Table 1. Response to RTS Fairfield City Council	
Matter Raised	Comment
A. PLANNING	
<p>The subject site is zoned RU4 Primary Production Small Lots. The proponent has not adequately demonstrated how the development is sympathetic to the rural environment, and how the development is of minimal risk from natural and man-made hazards.</p>	<p>The consolidation of internal learning areas and other internal facilities within a single, two (2) storey built form enables unbuilt-upon area and landscaping to be maximised over the site. Through the provision of vast open spaces and extensive landscaping, the site responds to its rural surrounds and maintains a 'green' and vegetated character.</p> <p>By contrast, the provision of multiple, detached buildings dispersed across the site in an arrangement more typical of older schools which have needed to provide additional facilities over many years to accommodate growth that was not initially planned for, would deplete the available open space and reduce landscaping. Such an approach to the design of the school would contribute to a site characterised by buildings rather than a green landscape, thereby compromising the rural character of the site

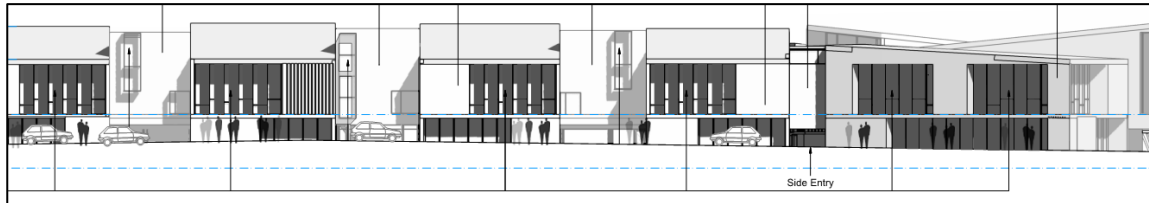
Matter Raised	Comment
	<p>With specific reference to the eastern elevation, the appearance of the length and overall scale of the building wall has been mitigated through the articulation of classroom spaces as separate building volumes, varied façade finishes, modulated roof forms, outdoor learning courtyards and boundary landscaping providing 'green screening'. Also of note, the building wall has been setback a minimum of 20m from the eastern side boundary, which significantly exceeds the 5m side setbacks required pursuant to FDCP and offers significant building separation from the adjoining property. Extracts showing the eastern elevation are provided at Figure 1-2 below.</p> <p>Therefore the design of the eastern elevation and eastern boundary setbacks are <i>not</i> considered to be in any way 'inappropriate'.</p> <p>Similarly, the proposal would <i>not</i> be inconsistent with the objectives of the RU4 zone. Council have specifically queried the proposal's consistency with the following zone objective:</p> <p><i>To ensure that development is sympathetic to the rural environment and minimises risks from natural and man-made hazards.</i></p> <p>As described in the above paragraphs, the development is <i>sympathetic to the rural environment</i> on the following basis:</p> <ul style="list-style-type: none"> ▪ The design integrates with the rural environment through maximising open space, unbuilt-upon area and landscaping over the site. ▪ The appearance of the bulk and scale of the built form has been managed through façade articulation, massing of different building envelopes, treatment of level changes, modulated roof forms, setbacks and landscaping. ▪ Vegetation planting adjacent to the site boundaries will soften views toward the site, riparian planting will enhance the environmental quality of the corridor in the site's west, and more than half of the site will be retained as open space.

Matter Raised	Comment
	<ul style="list-style-type: none"> Canopy trees proposed to be planted will extend above the height of the roofline, thereby assisting the scale of the development to integrate with its landscape. The amenity of surrounding rural properties has been safeguarded through generous boundary setbacks, extensive landscaping and planting of canopy trees. <p>Also consistent with the zone objective, the development has been designed to minimise risk from hazards through:</p> <ul style="list-style-type: none"> Compliant Asset Protection Zones (APZs); Siting buildings outside of the flood zone and minimising cut/fill in the flood zone; Remediation of land contamination on Lot 2321; Compliant riparian setbacks and planting within the riparian corridor; Balancing cut and fill and managing level changes. <p>At the same time as minimising risk to students and staff, these measures will protect natural processes, maintain natural landscapes and improve the environmental quality of the site.</p> <p>The proposal therefore achieves the zones objectives and offers an appropriate response to the rural character of the immediately surrounding context.</p>  <p>Figure 1. Eastern Elevation (PMDL, 2018)</p>
